## Sunnyside Cogeneration Associates

RE: Sunnyside Refuse and Slurry C/007/0035  
Task ID 4983 Midterm Completion Response

**Title:** Mid Term Permit Review

**- Task 4983 - Address additional comments received - Reclamation soil cover**

Sunnyside Cogeneration Associates  
**PERMIT TERM RECLAMATION PLAN**  
**BORROW MATERIAL PLAN**

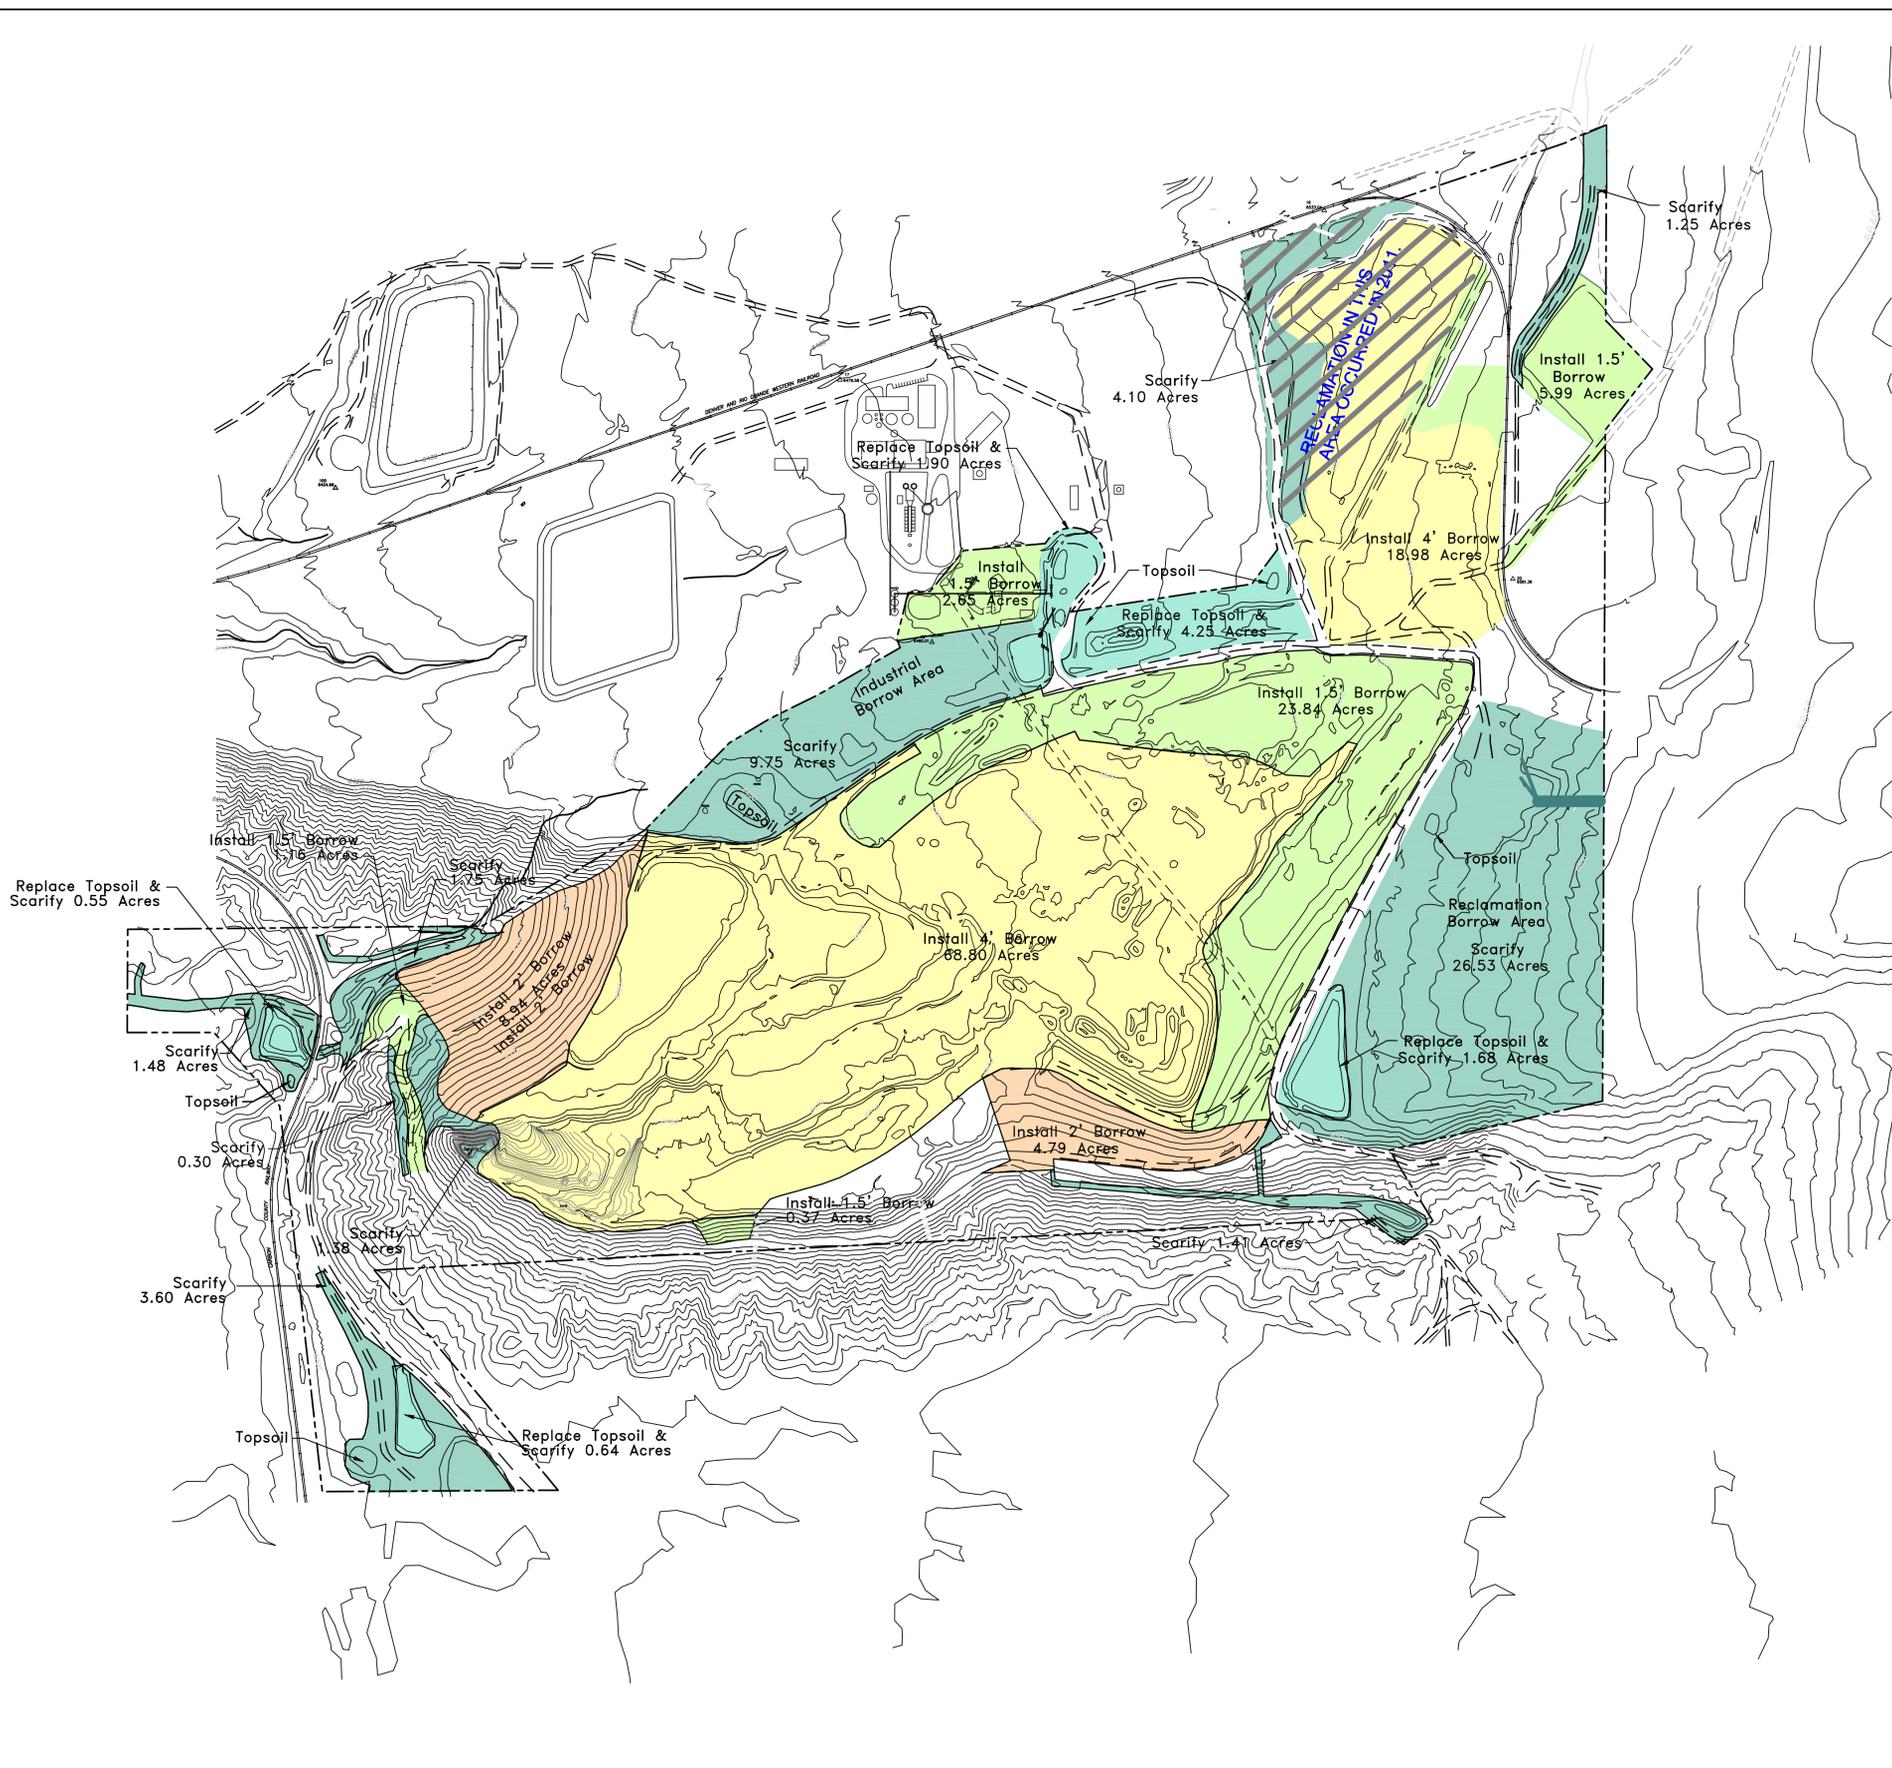
R645-301-121.100, The revised information does not meet the requirements of R645-301-230, Operation Plan, because the topsoil piles (Clear water pond, Hoist house, and Slurry Pond topsoil piles) which are no longer existent are still shown on Drawings 2-1 and 5-1. In addition, Plate 8-4 reduces dedicated topsoil replacement volumes because of the use of the aforementioned topsoil stockpiles, but does not reduce the area to receive the topsoil which is inconsistent with the narrative.

related to the Division's Midterm Review. In order to avoid mixing the issues, we have left the colored shading as it was previously approved on 8-4 representing the borrow material cover and topsoil cover requirements. SCA will make a separate submittal to request the phased bond release and adjust the colored shading, acreages and volumes associated with the required reclamation cover.

Drawing 8-4 has also been updated with this amendment package. The volume of topsoil available does reflect that the mentioned topsoil stock piles have been used in the reclamation work. The reclaimed area is crosshatched on drawing 8-4 and notes have been added to the drawing. SCA will be requesting phased bond release separately from this amendment which is

Scarify Soil Prior To Seeding =	51.6 AC
Regrade, Scarify & Replace Topsoil =	9.0 AC
Topsoil =	4183 CY
